Service Bulletin

Bulletin No.: 17-NA-237

Subject: Wet Floor or Interior Water Leak due to HVAC Drain Hose

Brand:	Model:	Model Year:		VIN:		Engine:	Transmission:
		from	to	from	to		
Chevrolet	Equinox	2010	2017			All	All
GMC	Terrain	2010	2017			All	All

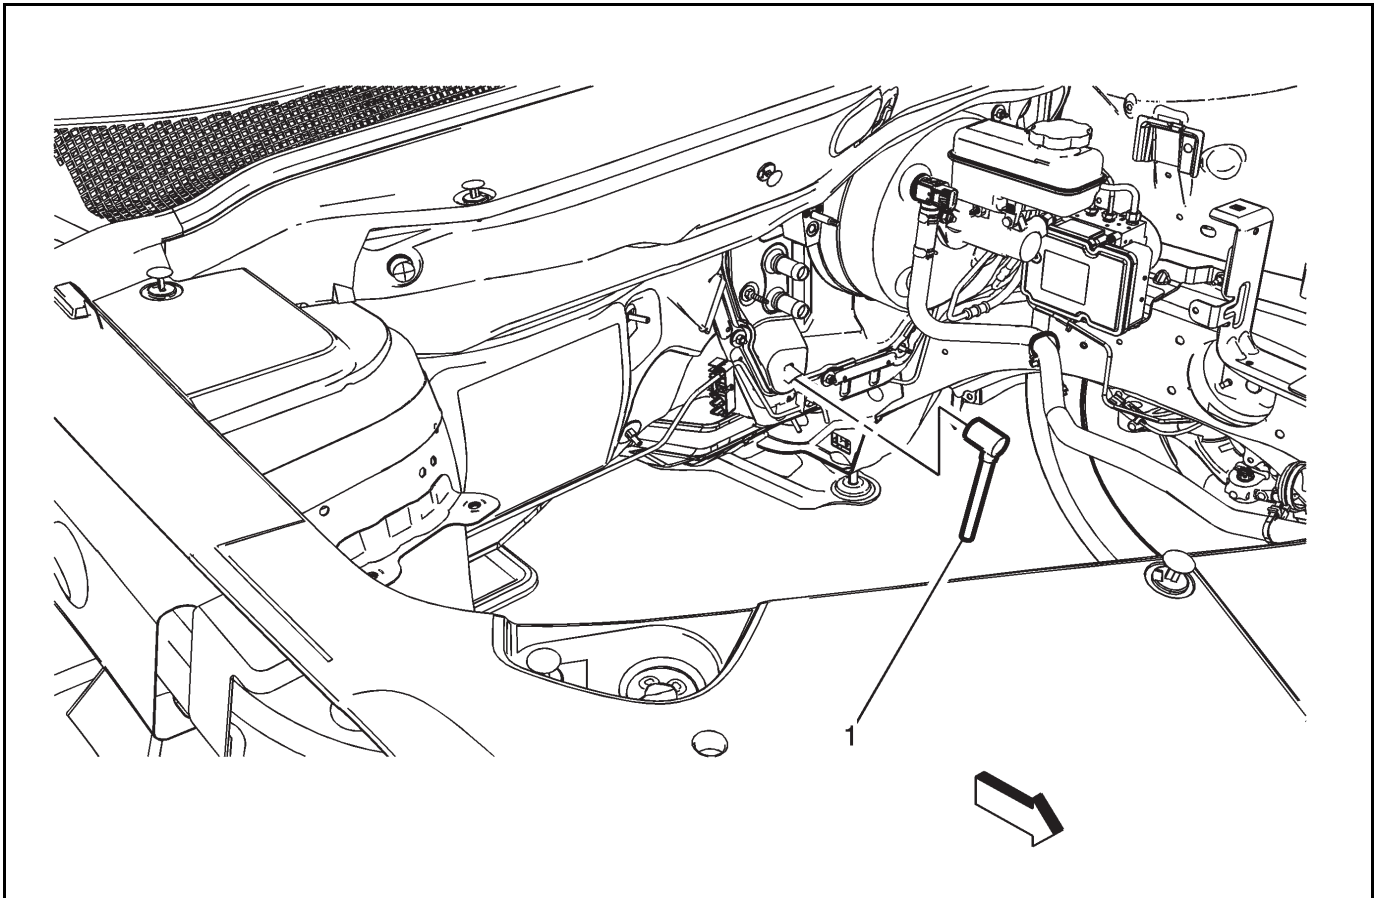
Involved Region or Country	North America, Middle East, Israel
Condition	Some customers may comment on an interior water leak and/or the floor is wet. During diagnosis a technician may find that the leak is due to the HVAC drain hose.
Cause	This may be due to the older design drain hose being a smaller diameter that is prone to clogging.
Correction	Replace the drain hose with newly designed drain hose.

If you encounter a vehicle with the above concern, replace the drain hose. Refer to *Air Conditioning Evaporator and Blower Module Drain Hose Replacement* in SI.
